LOUISIANA
POWER & LIGHT

W3P86-0021
A4.07
NQA

Subject: Waterford SES Unit 3
Docket No. 50-382
Safety Parameter Display System

TENTATIVE SPDS DISPLAY

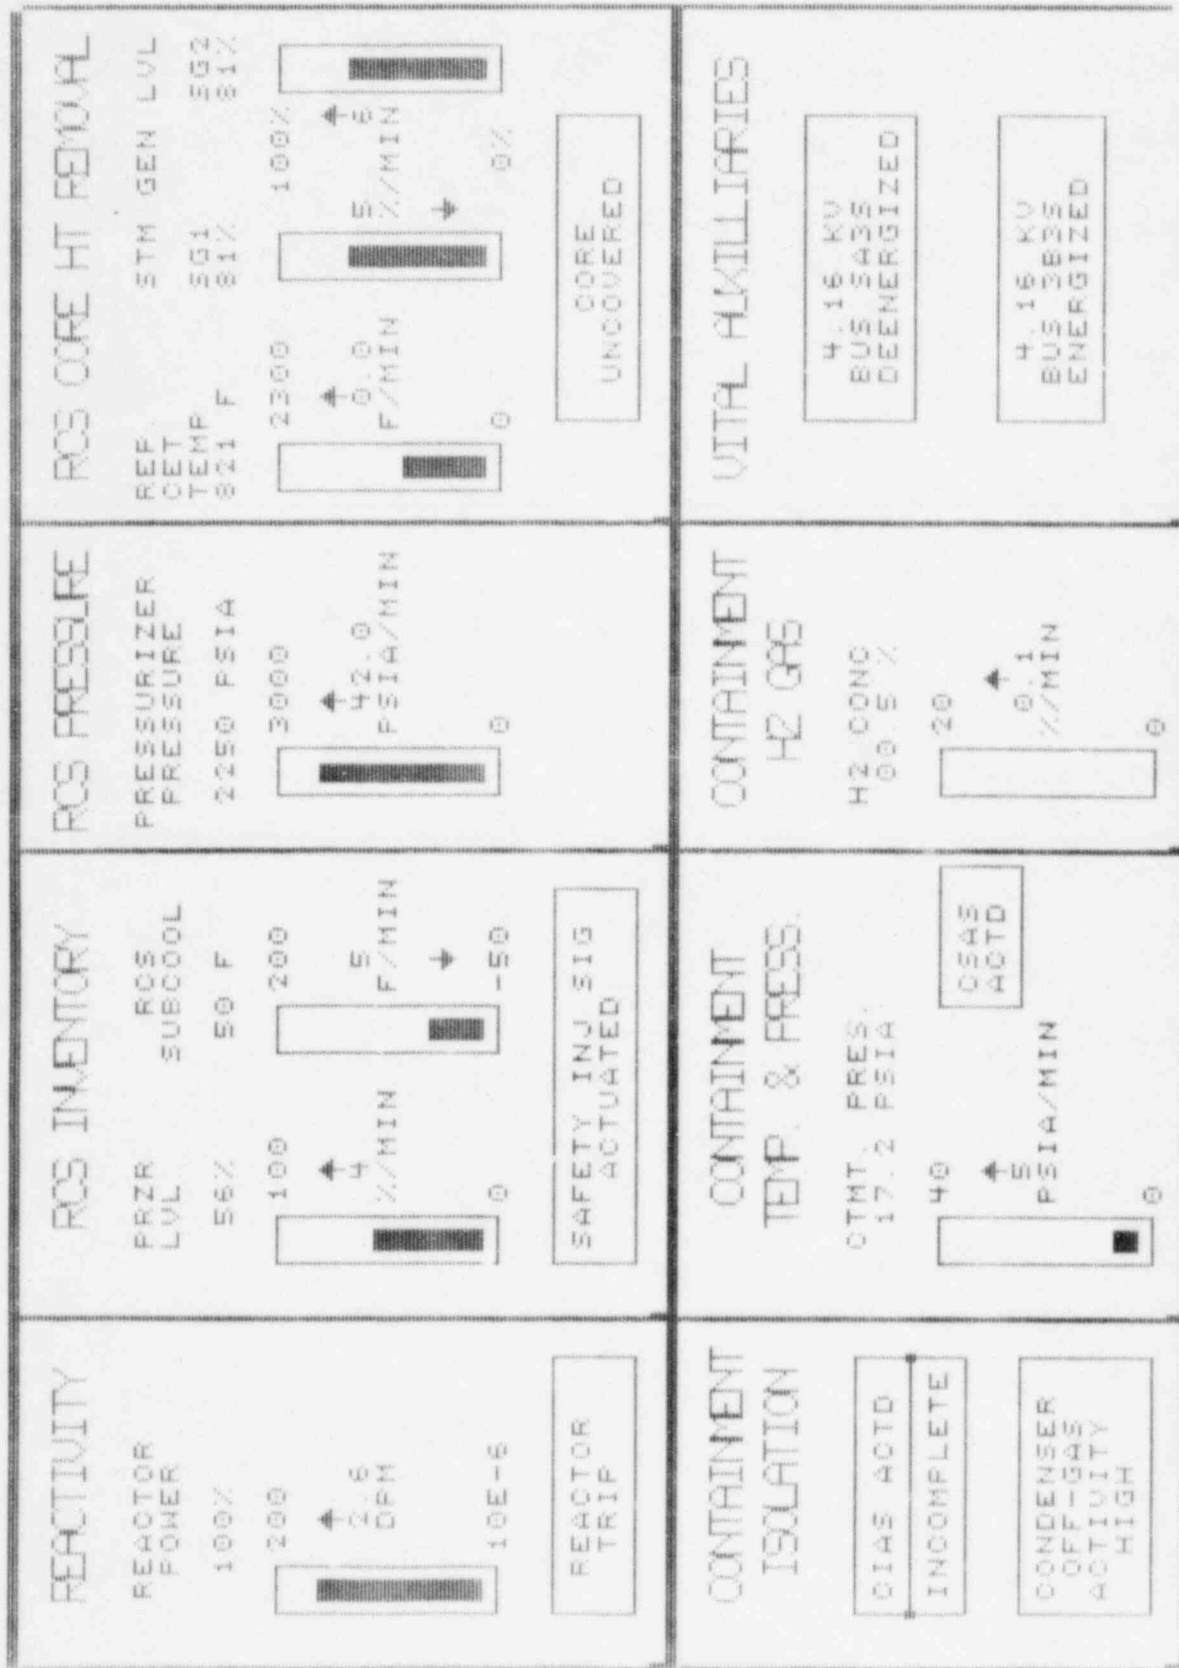
Attachment 1 describes the enhanced set of SPDS critical parameters while Attachment 2 depicts the tentative display design for the SPDS. By following this scheme the Waterford 3 SPDS will be defined as a one page display that will be continuously available in the control room, and continue to meet the requirements of Supplement 1.

- o The SPDS will be enhanced through redefinition of the critical parameter set as defined by Attachment 1.
- o The SPDS will consist of one display, tentatively shown in Attachment 2.
- o All enhancements to the SPDS will be implemented to conform with Supplement 1. NUREG 0800 will not be used as a basis for enhancements (e.g. V&V program).
- o The enhancements are estimated to require 10 months, however, LP&L does not intend to implement the enhancements until final resolution of the SPDS audit report and acceptance of the enhancements by the NRC.
